**Historic Architectural Review Commission  
Staff Report for Item 8**

**Application Number:** H2018-0003

**Address:** #215 Eneas Lane

Demolition of existing structure. Second reading

1962 Sanborn Map

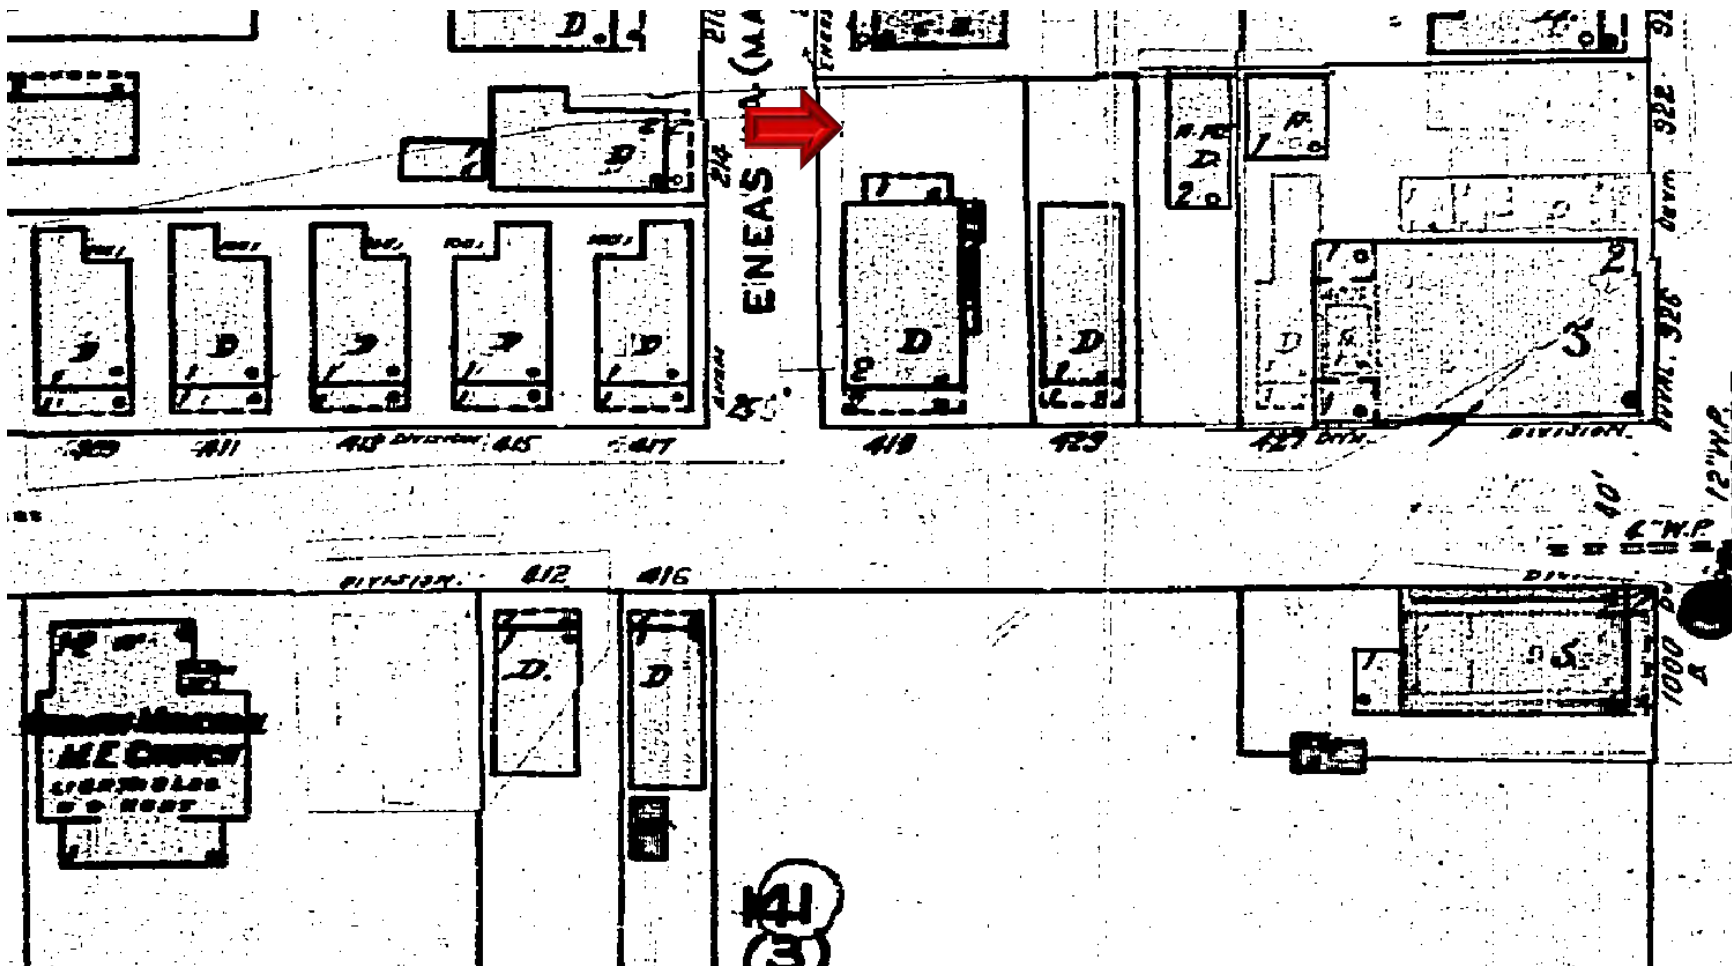
The cbs site in question has a one-story structure that is not in the surveys. The structure is severely altered, as it currently has no resemblance in footprint with the drawings depicted in the Sanborn maps. The structure used to be accessory to 419 and 423 Truman Avenue. Parts of the historic concrete exterior walls are still standing.
